**WHITEMARSH TOWNSHIP
SHADE TREE COMMISSION MEETING AGENDA
FEBRUARY 3, 2026 AT 6:30 PM (IN-PERSON)**

- Grading Permit #2025-22 Stenton Ave. Trust; Construction of Single-Family Dwelling & Associated Improvements; PARCEL ID 65-00-11131-009

In reference to the above-mentioned property, we have reviewed plans prepared by Yohn Engineering, LLC, dated September 18, 2025, and last revised January 19, 2026. The following comments must be resolved before an earth disturbance permit can be issued for this project.

| SHEET NAME: | POST CONSTRUCTION STORMWATER MANAGEMENT PLAN |

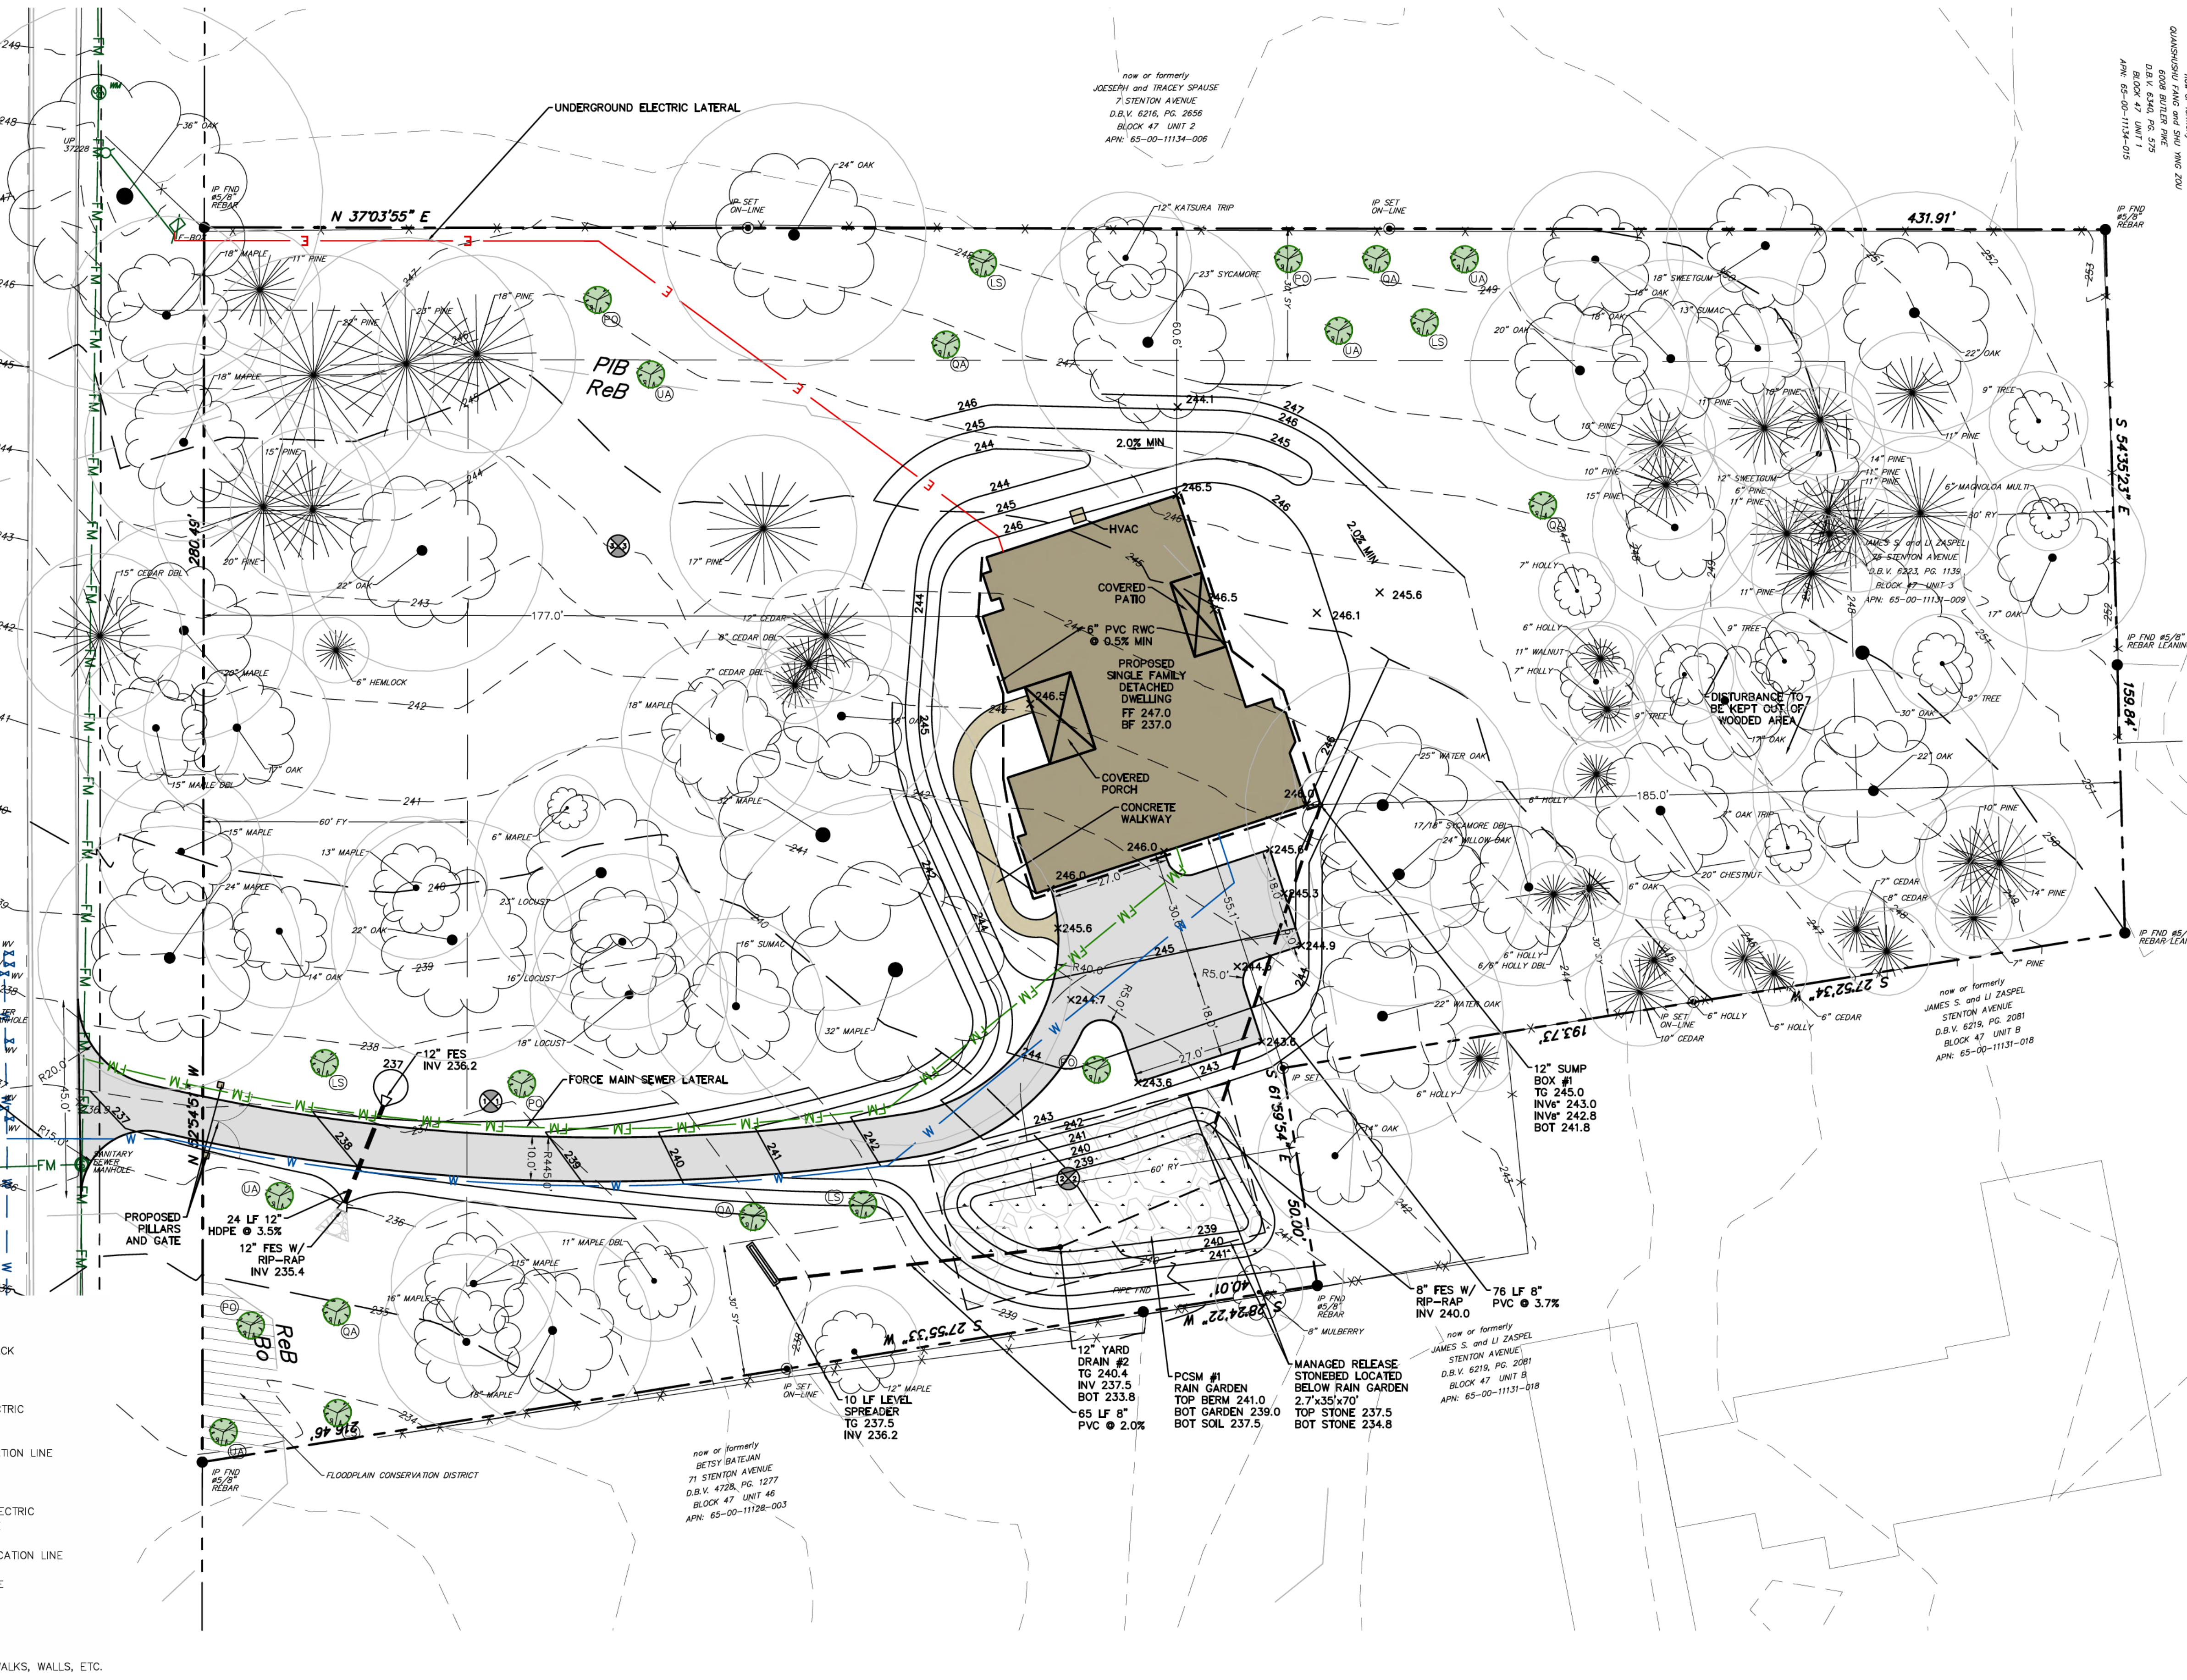
| <u>Section</u> | <u>Description</u> |
|-----------------|---|
| 1. 58-17 | There is an errant dimension label over the Post Construction Stormwater Management Installation Note on Sheet 2, which must be removed. The Construction Notes on Sheet 2 must be revised as follows: <ul style="list-style-type: none">Note 3 must be revised to state that the permit is required from PennDOT.Note 4 must be revised to state that the permit is required from the Whitemarsh Authority. |

SHEET NAME: EROSION AND SEDIMENTATION CONTROL PLAN

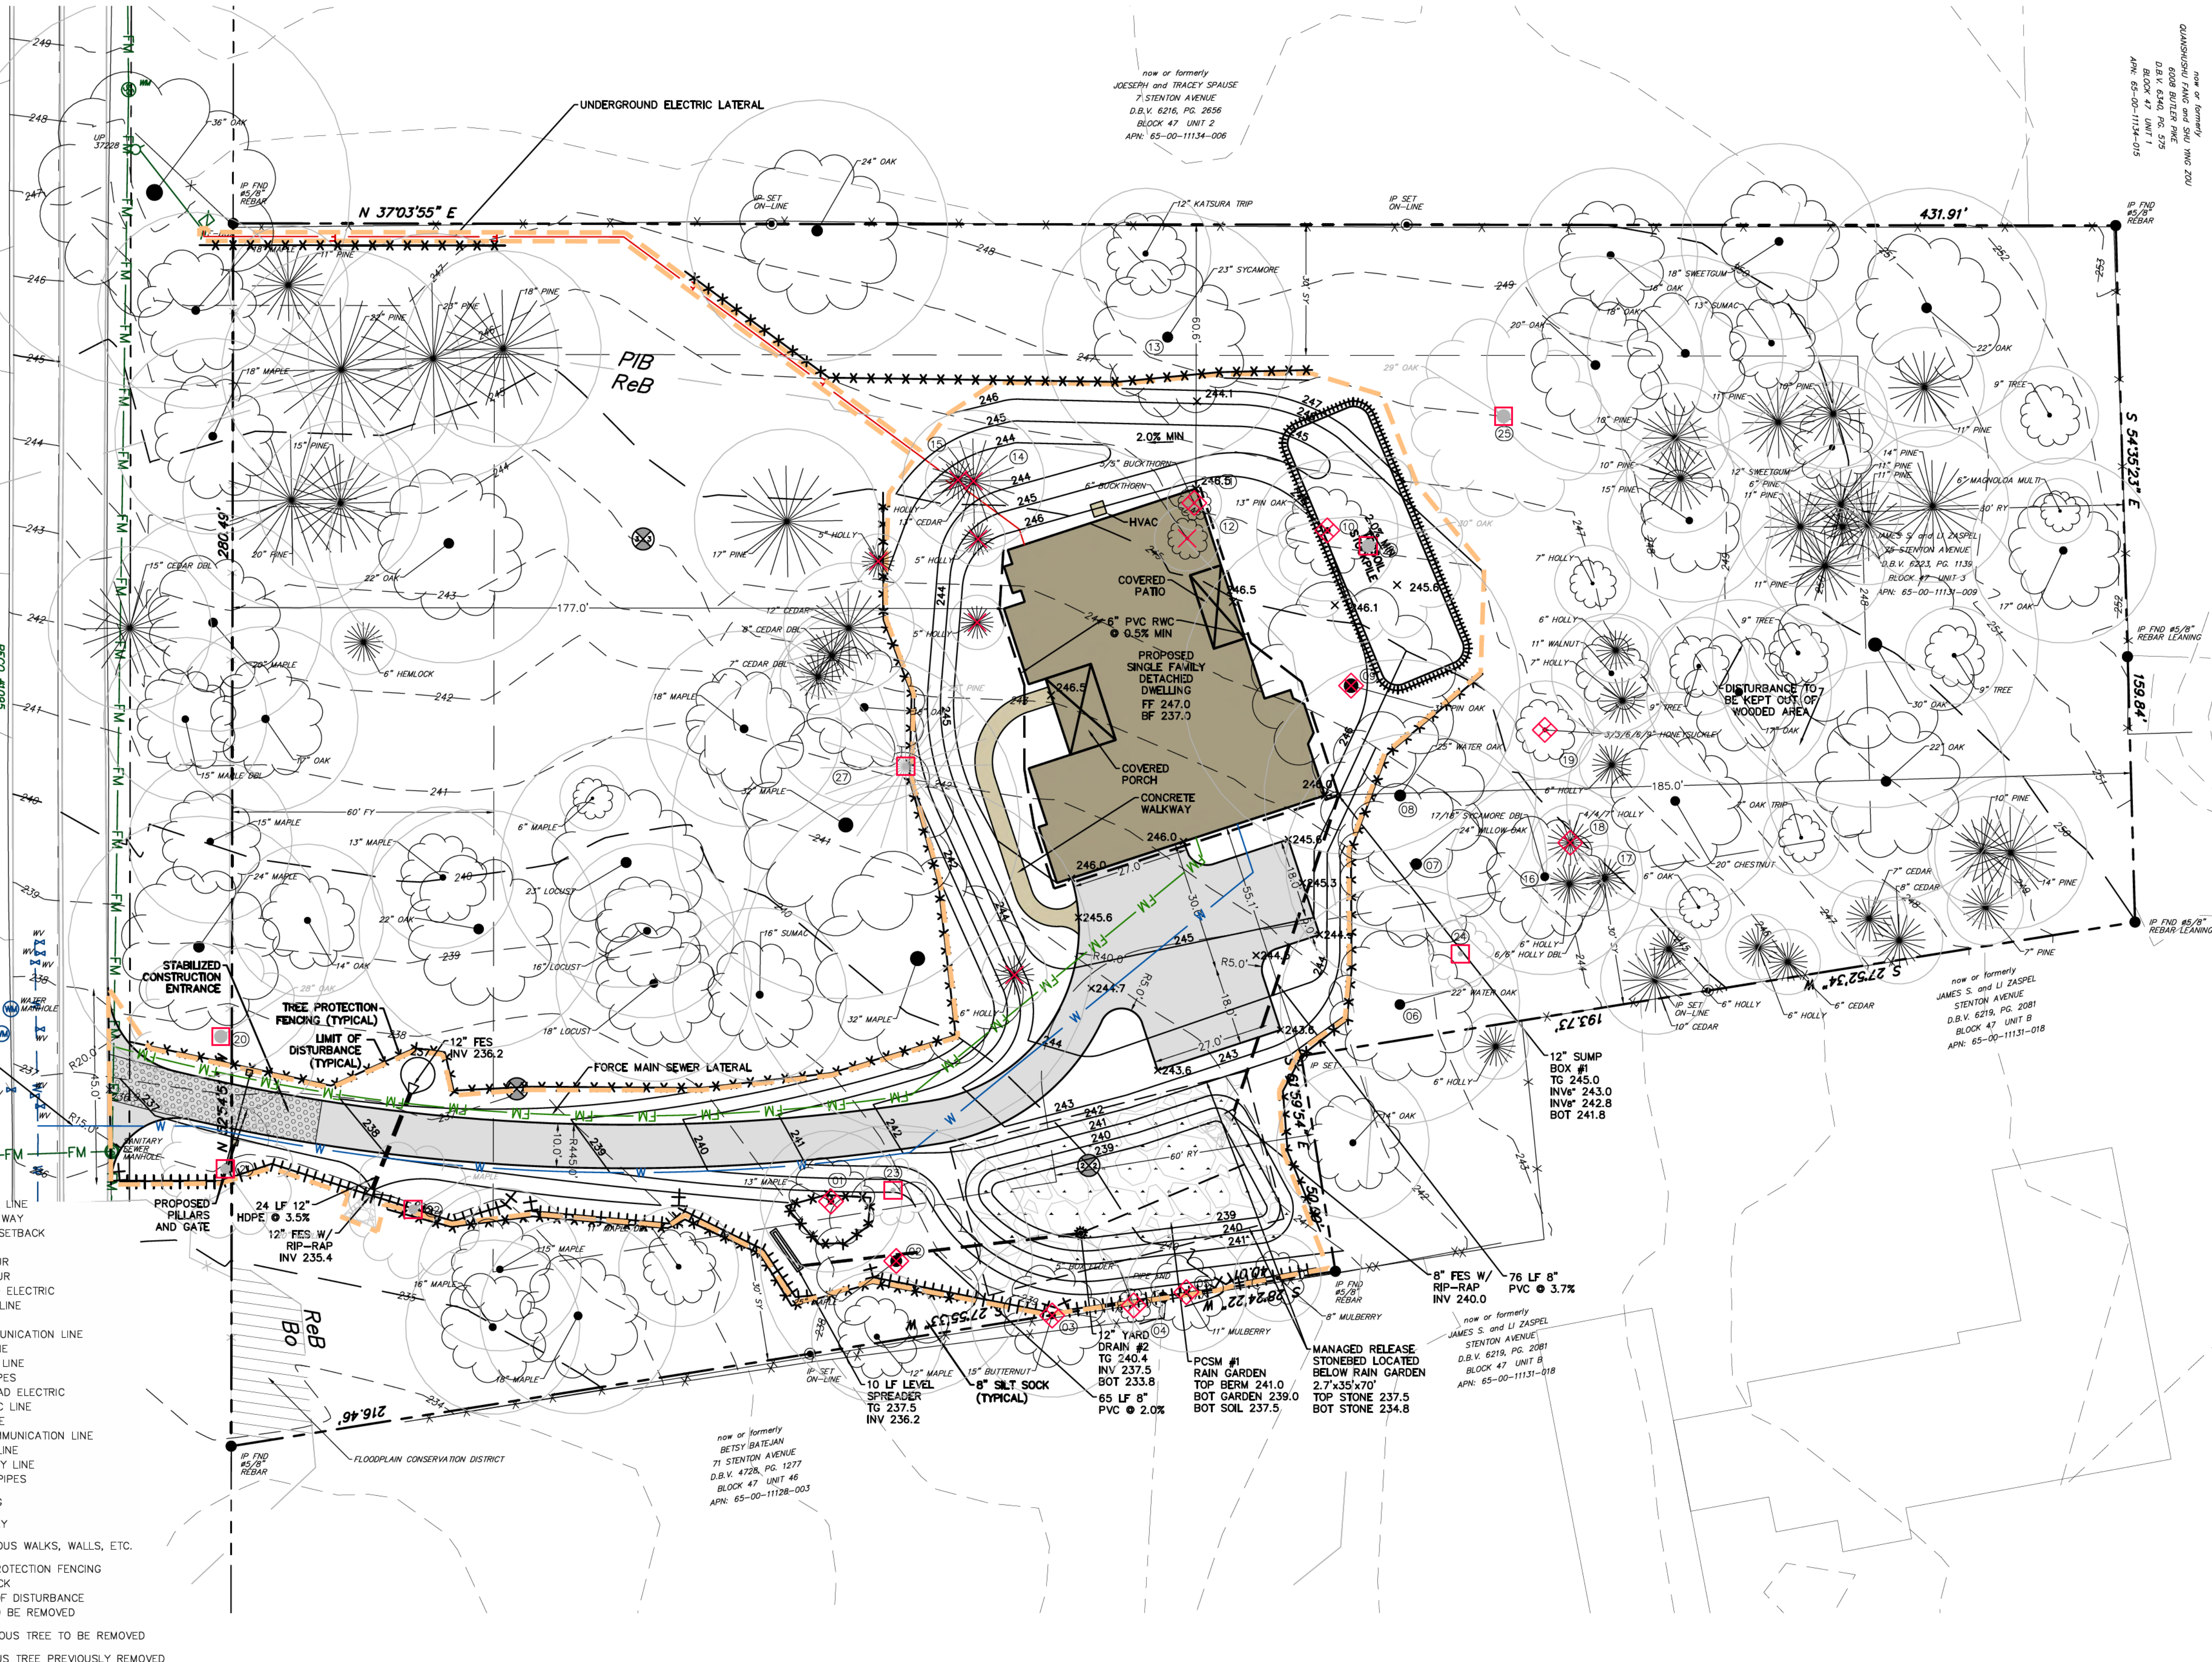
| <u>Section</u> | <u>Description</u> |
|-----------------|---|
| 2. 58-28(D)(11) | The plans must be revised so that the proposed contour line representing an elevation of 241, near the stormwater BMP, does not extend off of the subject property. |

| <u>Section</u> | <u>Description</u> |
|------------------|--|
| 4. 55-4(C)(4)(b) | The plans show tree protection fencing within the root protection zone, as established by one of the following two means, whichever is greater: [1] Calculated at 1.25 feet (radius) per one inch of (DBH) diameter breast height. [2] A circle with a radius extending from a tree's trunk to a point no less than the furthest crown dripline. |
